BELLEFONTE COMBINED LICENSE APPLICATION – ITEMS IDENTIFIED IN NRC
HYDROLOGY RELATED SITE VISIT TRIP REPORT

Reference: Memorandum from Joseph Sebrosky (NRC) to Stephanie Coffin (NRC), Trip
Report – May 13-16, 2008, Hydrology-Related Site Visit in Support of the
Bellefonte Combined License Application, dated June 12, 2008

Enclosure
TVA letter dated July 23, 2008
Trip Report Actions

**NRC Hydrology Site Visit Trip Report Action 3
Related to Discussion Items 12 and 25**

Figure 1a: Conceptual Groundwater Pathway #1

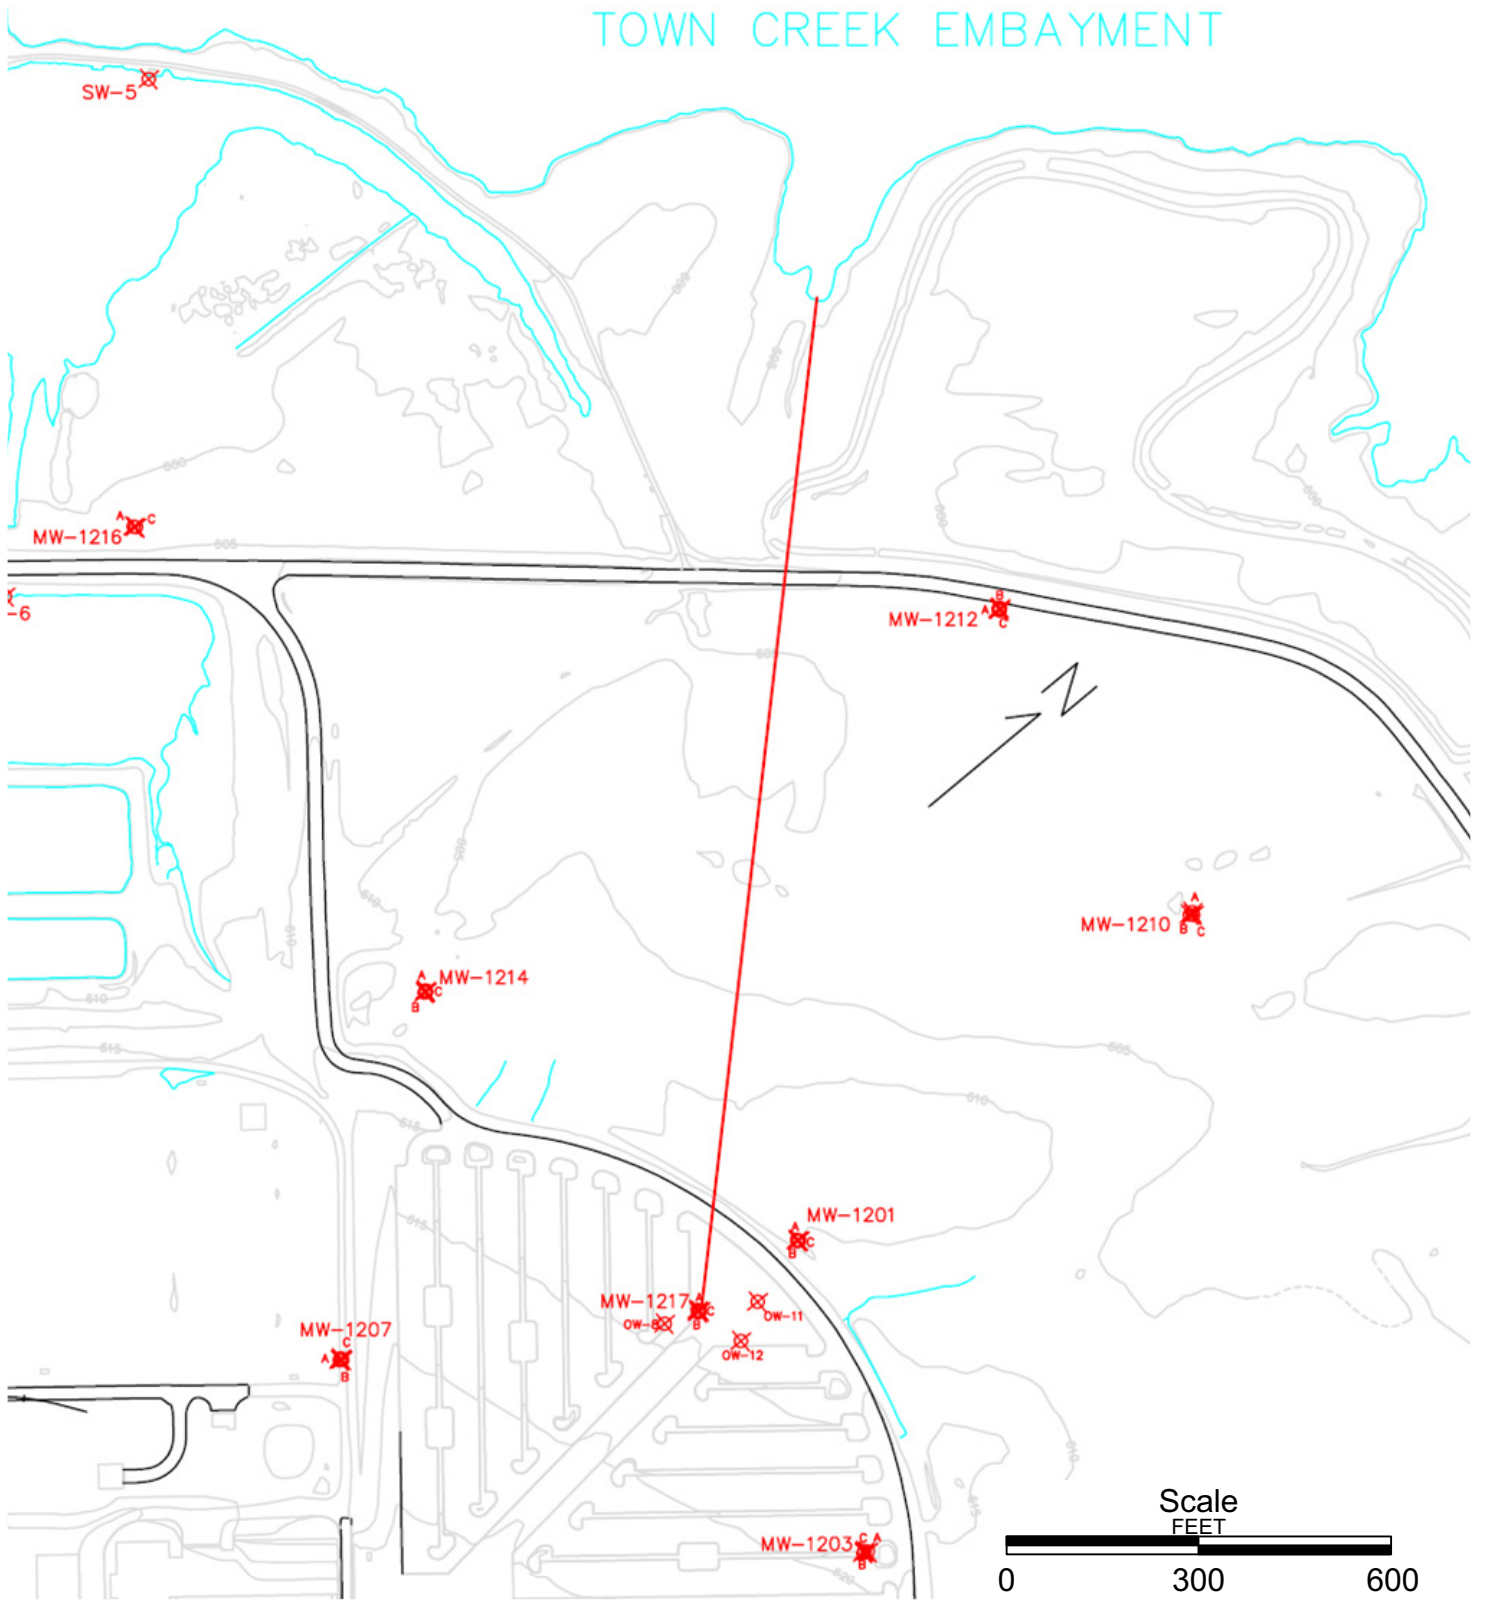
The groundwater velocities for the BLN site have been recalculated using a formation porosity of 0.018 and the B-1046 packer test hydraulic conductivity of 4.2×10^{-3} cm/s with the calculated monthly groundwater velocities (in ft/day) from Unit #3 towards Town Creek (Figure 1a) as follows:

Figure 1b: Conceptual Groundwater Pathway #2

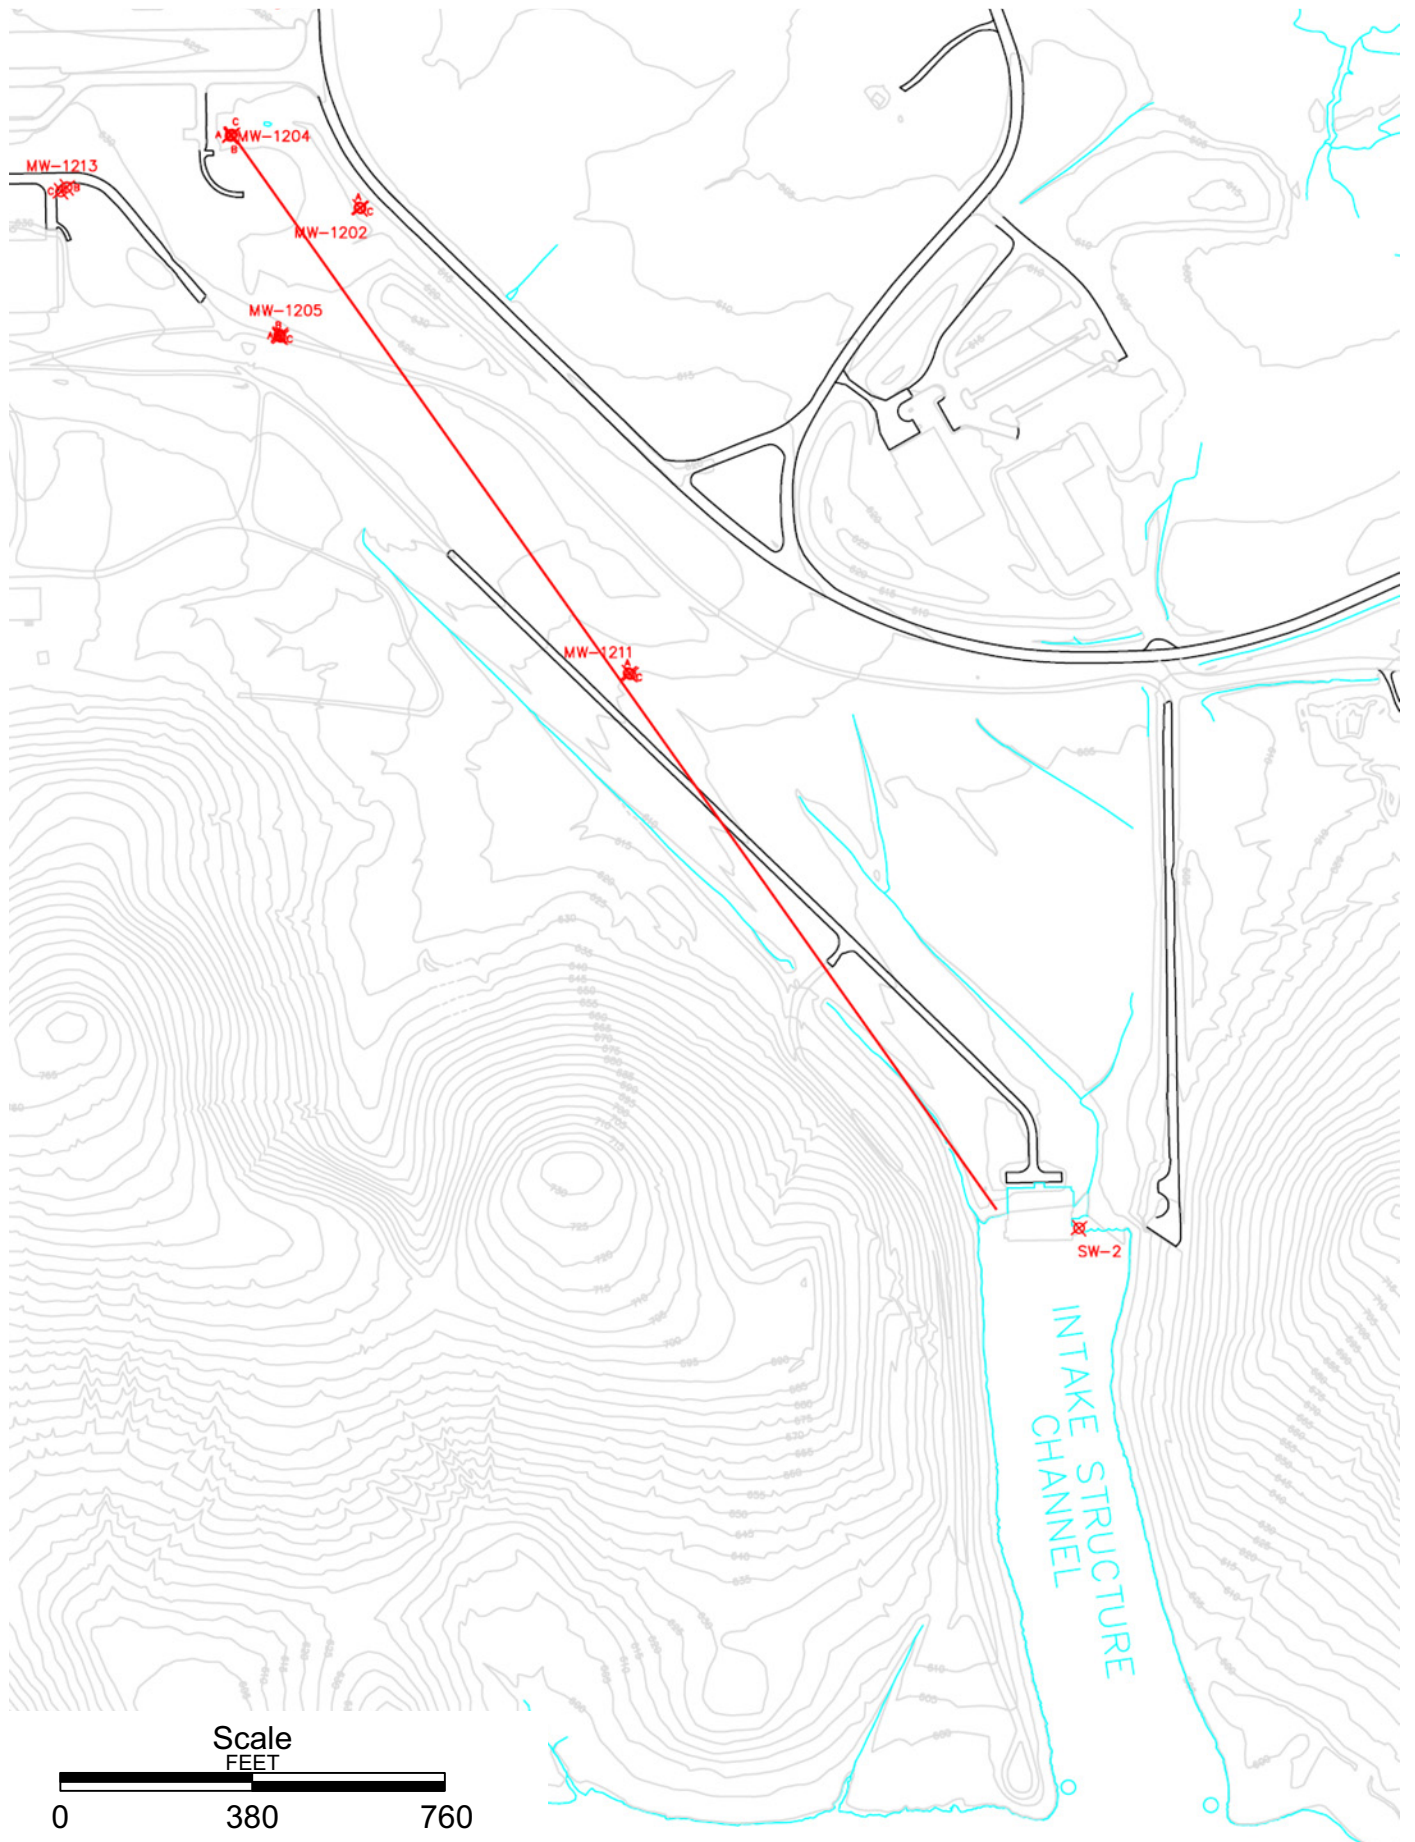
Although the conservative groundwater pathway was assessed from Unit #4 to the Intake Channel (see Figure 1b), this pathway is considered unlikely due to the flow dynamics near the southeast edge of the Unit #4 construction zone and monthly variations in observed groundwater flow gradient direction.
